Access Compliance Report Public Rights-of-Way (Curb Ramps)

Intersection ID: 13305 Main Street: W_BLAND_ST **Cross Street: WINNIFRED ST** Location: Ε **ADA ID: 35BFEA5195F5** Ramp Type: PerpDiag Initial Pass/Fail: Fail **Overall Compliance: No Severity Score:** 12.5

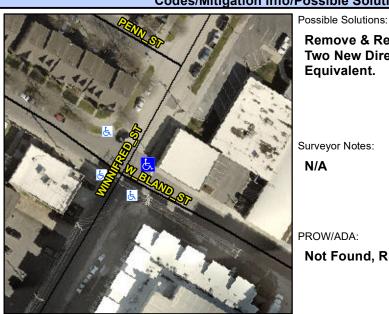
Not Found, R304.2.2

| Field Measurements/Component Compliance | | | | | |
|---|-----------------------|-------|--------------------|-----------------------------|-------|
| N/A | Ramp Length (in) | 48.0 | No | Ramp Slope (%) | 9.7 |

Street 1 Name Stop Condition-Street 2 Street 2 Name Stop Condition-Street 1 **WINNIFRED ST** StopSign W BLAND ST StopSign Remove & Replace Curb Ramp With Two New Directional Ramps or Equivalent.
